Veterans Administration Medical Center
Bath, NY

Project: FCA Upgrade Auditorium, Bldg. B92
VAMC Project # 528A6-12-606

ADDENDUM #1

4 June 2013

Auditorium Elevation (Toward Lobby Exit)
 SCALE: 1/4" = 1'-0"

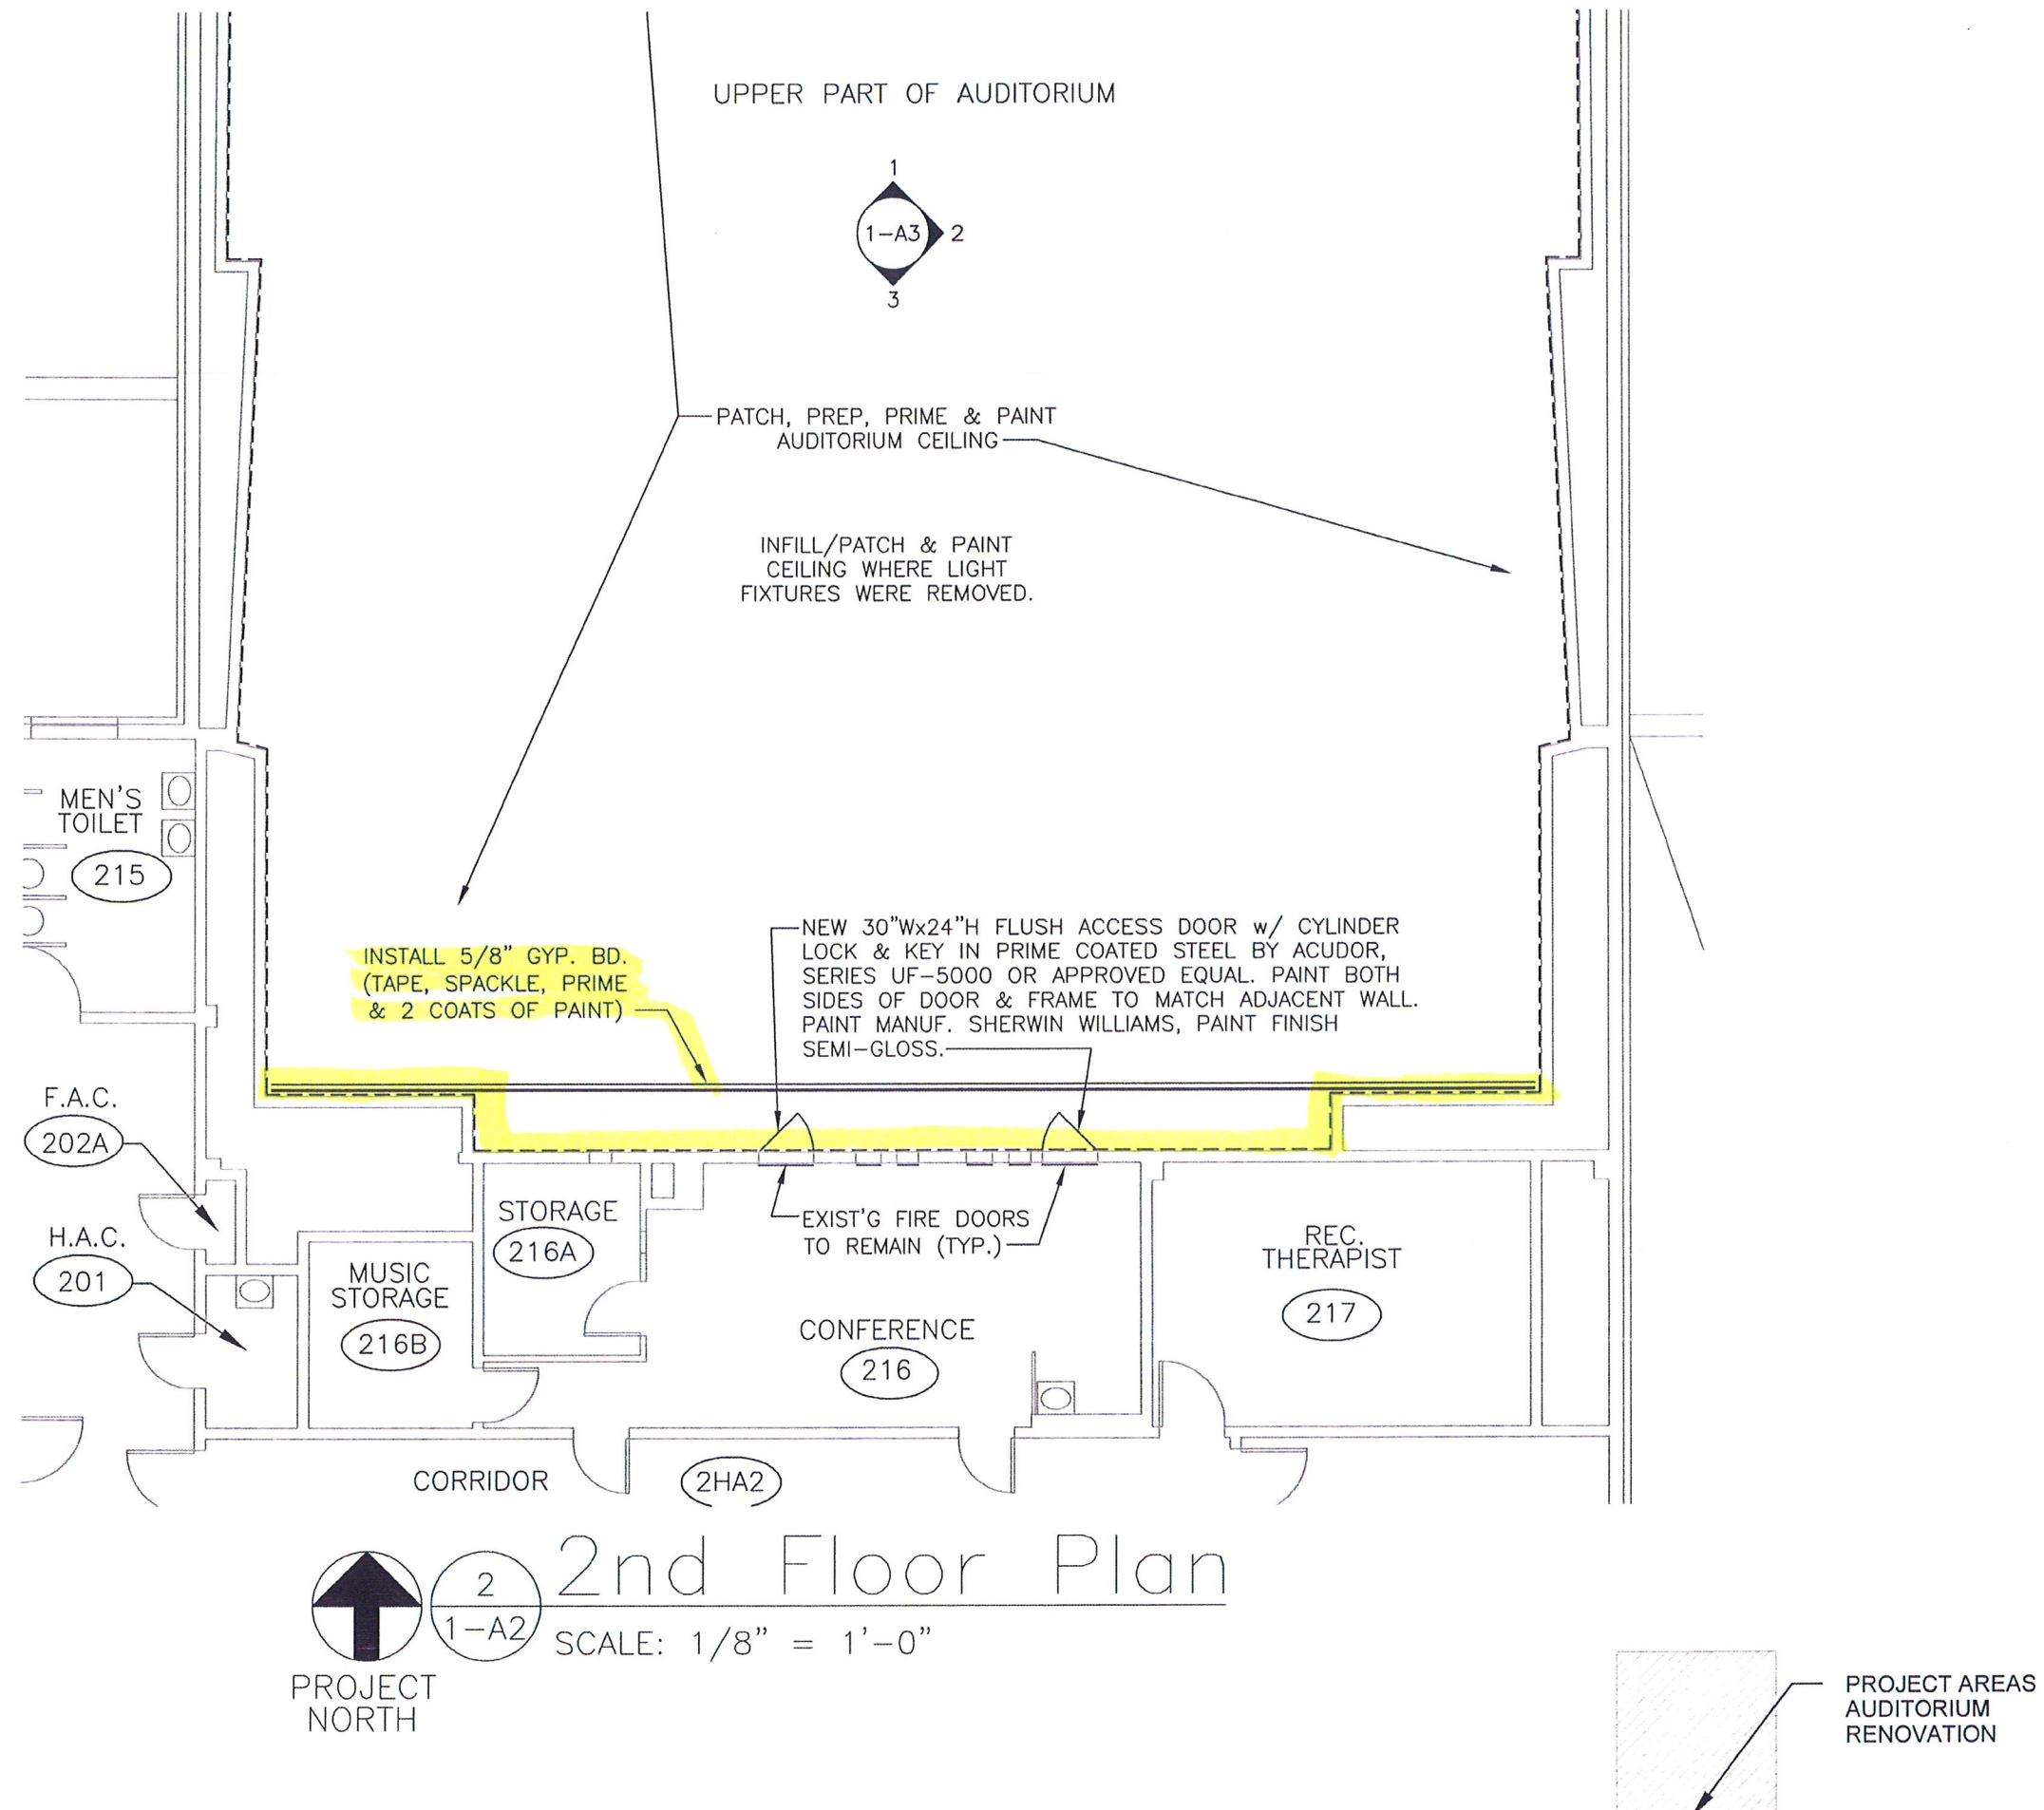
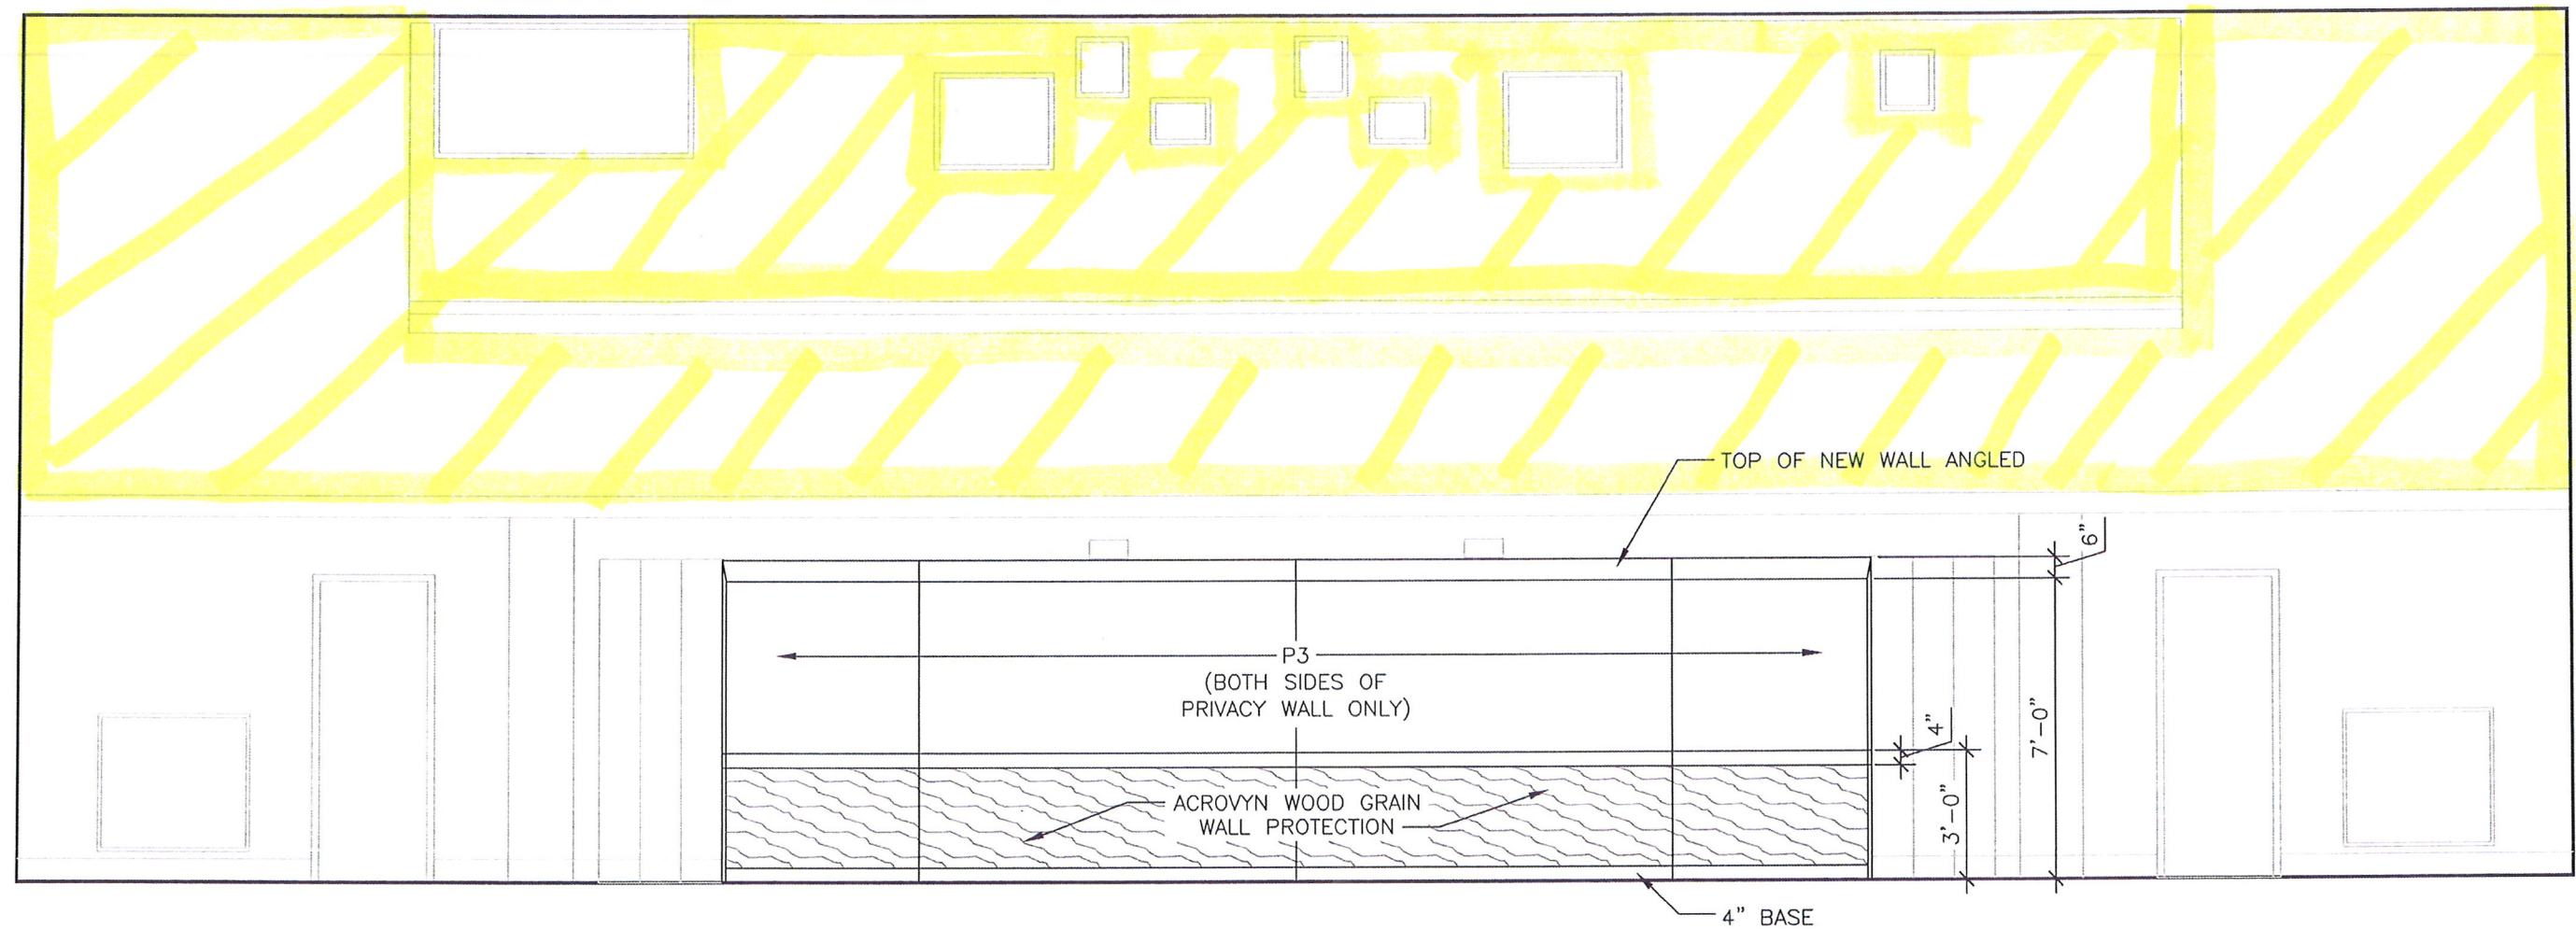
- A. See attachment #3 for Table 2 – Summary of Positive Asbestos Containing Materials and Asbestos Survey Summary Plan – First Floor of Bath VA Medical Center, Building 92.
- B. See attachment #4 for extent of drywall installation on the south wall, second story.
